Subject: Att: Olivia Ramage - Planner : Objection to DA Number DA2024/0011

RE: Objection to Development Application, Application Number DA2024/0011 – 138 Lagoon St NSW 2101

Figure 2.1 – Current view from our balcony/entertainment area

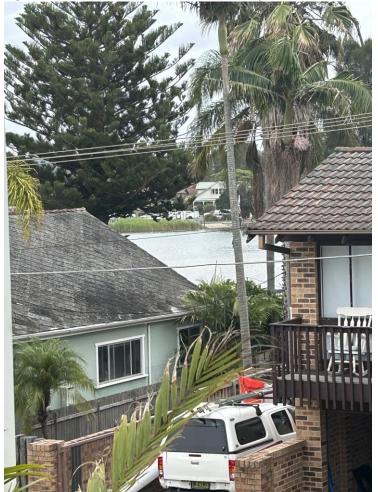
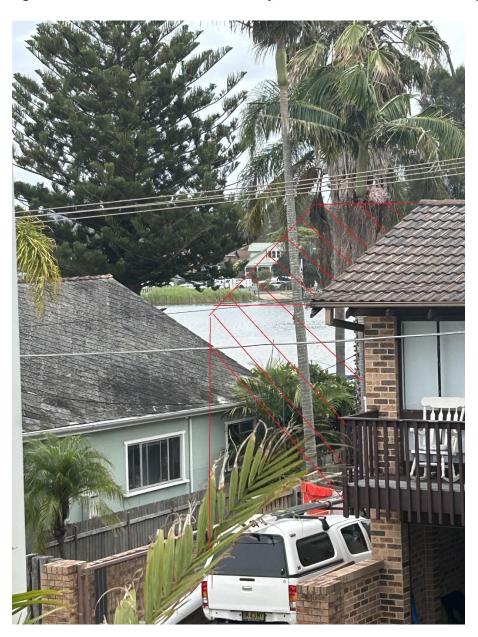
We currently have views of Narrabeen Lagoon as well as the trees/foliage to the northwest in the space between the current dwelling of the Proposed Development and 15 Malcolm St. Therefore, I disagree with the statement under 'Views (DCP D7)' that our views as neighbours will not be affected by the proposed addition of a carport and roofed balcony extension on the western side of the Proposed Development.

If the Proposed Development does go ahead, it will effectively block the only water view we have in this direction.

Also as the proposed balcony will be full enclosed, it will replace our water view with a large amount of bulk and scale to our aspect in this direction.

Figures 1 & 2 below show our current water view as well as how our view will be blocked if the Proposed Development of extensions of balcony and carport go ahead.
